## Tree Conservation Plan Adjustment Application

Street address or location of subject property	6719 Devon Avenue SE
Lot size	19.74 Acres
Proposed use or type of development	SUB
Original Tree Conservation Plan (TCP) case number	TCP21-02
Associated Subdivision/Partition case number	SUB21-01

**PROJECT:** Devon Subdivision

**RE:** *TREE CONSERVATION PLAN ADJUSTMENT FOR TCP21-02*

PRELIMINARY  
TREE CONSERVATION  
PLAN - ONSITE: WEST

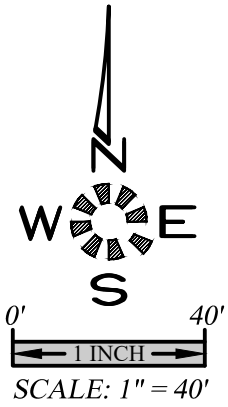
ENCLOSED IS A TREE CONSERVATION PLAN ADJUSTMENT FOR THE DEVON SUBDIVISION (SUB21-01). AFTER BEING OUT ON THE SITE, IT WAS DETERMINED THAT THE CHERRY TREE LOCATED ON LOT 5 NEEDS TO BE REMOVED. DUE TO GRADING ON THE SITE, THE FIR TREE ON LOT 37 NEEDS TO BE REMOVED AS WELL.

THE APPLICANT IS REQUESTING A TREE CONSERVATION ADJUSTMENT IN ORDER TO REMOVE THE CHERRY TREE LOCATED ON LOT 5 AND THE FIR TREE LOCATION ON LOT 37 OF THE SUBDIVISION. ON MAY 3, 2021, THE APPLICANT WAS GIVEN APPROVAL TO REMOVE 47 TREES ON THE SITE THROUGH TREE CONSERVATION PLAN (TCP) 21-02.
